Subject: INTERFERENCE BETWEEN SOFT TOP AND BELTLINE MOLDING	Bulletin No: 09-018/06
	Last Issued: 5/4/2006

APPLICABLE MODEL(S)/VINS

2006 MX-5 vehicles with VINs lower than JM1 NC**** ** 110950 (produced before December 19, 2005)

ADD SPACER/WASHER TO INCREASE CLEARANCE BETWEEN SOFT TOP AND BELTLINE MOLDING

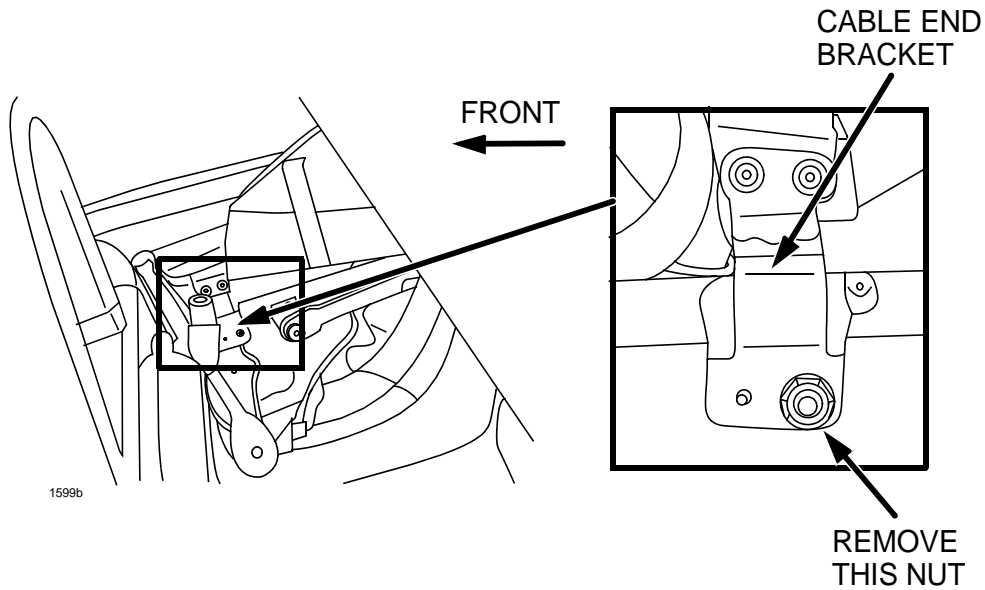
Some vehicles may experience the convertible soft top makes contact with the beltline molding near the door. In some cases, this may cause difficulty in opening and closing of the convertible soft top and may cause damage to the cable end bracket.

As a mass production change, the shape of the cable end bracket has been changed to increase the clearance. Customers having this concern should have their vehicle repaired using the following repair procedure.

1. Verify customer concern. Visually inspect cable end bracket.
 - If there is interference between the soft top cloth and beltline molding and the cable end bracket is ok, go to STEP 2.
 - If the cable end bracket is bent or broken, proceed to REPAIR PROCEDURE "B" (VEHICLES W/DAMAGED CABLE END BRACKET(S)).
2. Remove the cable end bracket nut and remove bracket from stud.

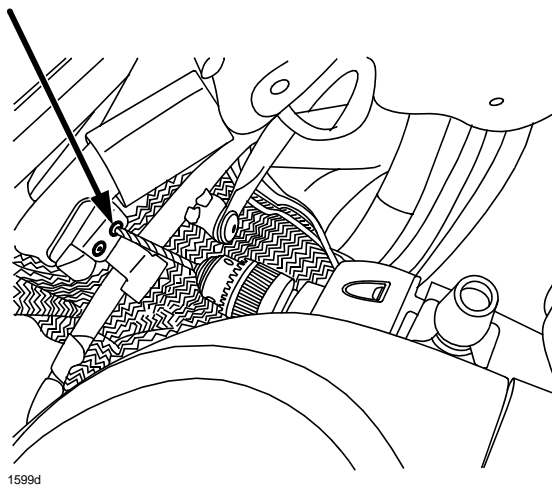
3. Add a washer (1.0 mm – 1.5 mm thick) between the cable end bracket and convertible top frame.

4. Install cable end bracket over the washer. Tighten the nut. *Tightening torque: 7.8 – 10.7 Nm*
5. Verify repair.

REMOVE RIVETS SECURING
CABLE END BRACKET USING
A 4 mm DRILL

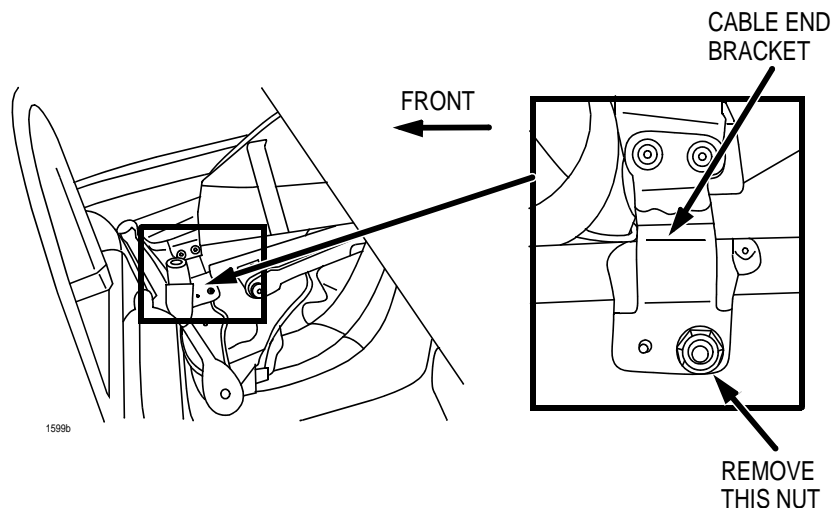
- If you install cable end brackets (A-level part), as noted in this bulletin, you don't need to add a washer.
1. Verify customer concern.
 2. Place a cloth under the area to be drilled to catch shavings and prevent damage to the soft top while drilling out rivets.
 3. Remove the rivets securing the cable end bracket using a 4mm drill bit.

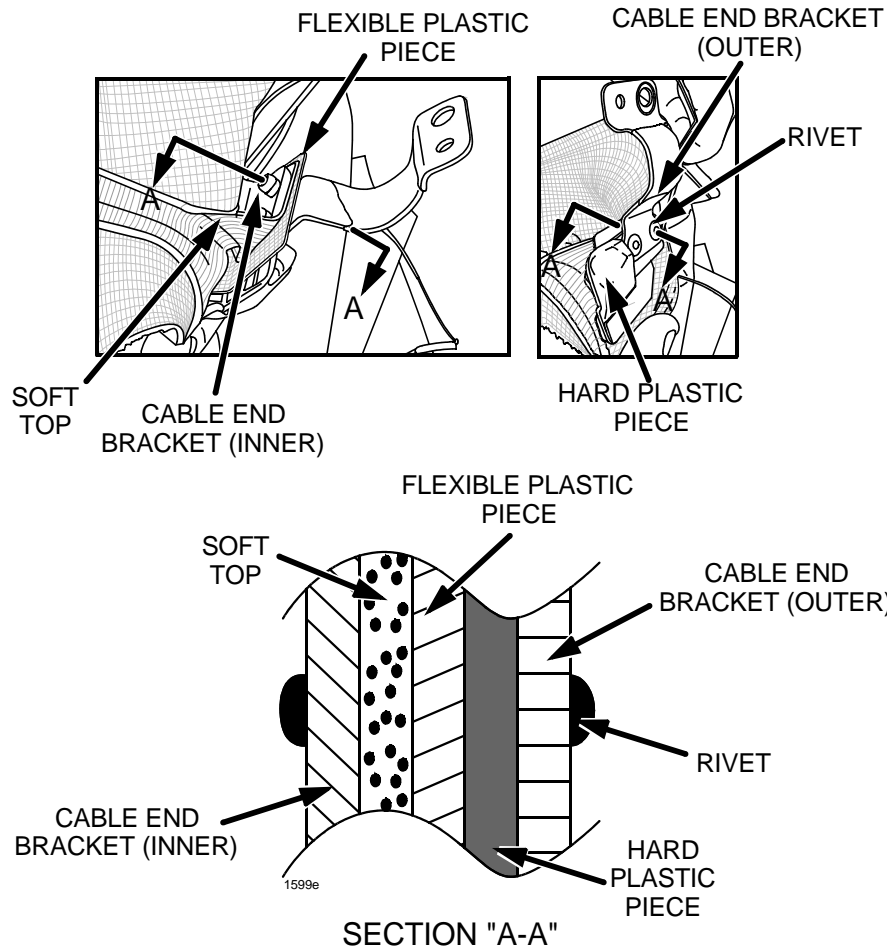
4. Loosen the nut and remove the damaged cable end bracket.

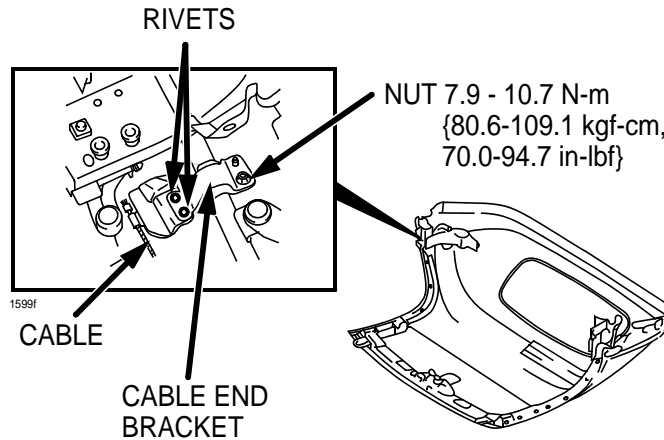
5. Secure a new cable end bracket with new rivets. Ensure items are placed in the correct order shown before installing new rivets.

6. Install cable end bracket over the stud. Tighten the nut. *Tightening torque: 7.8 – 10.7 Nm*

- Illustration shown for informational purposes only, DO NOT remove the convertible top from the vehicle.
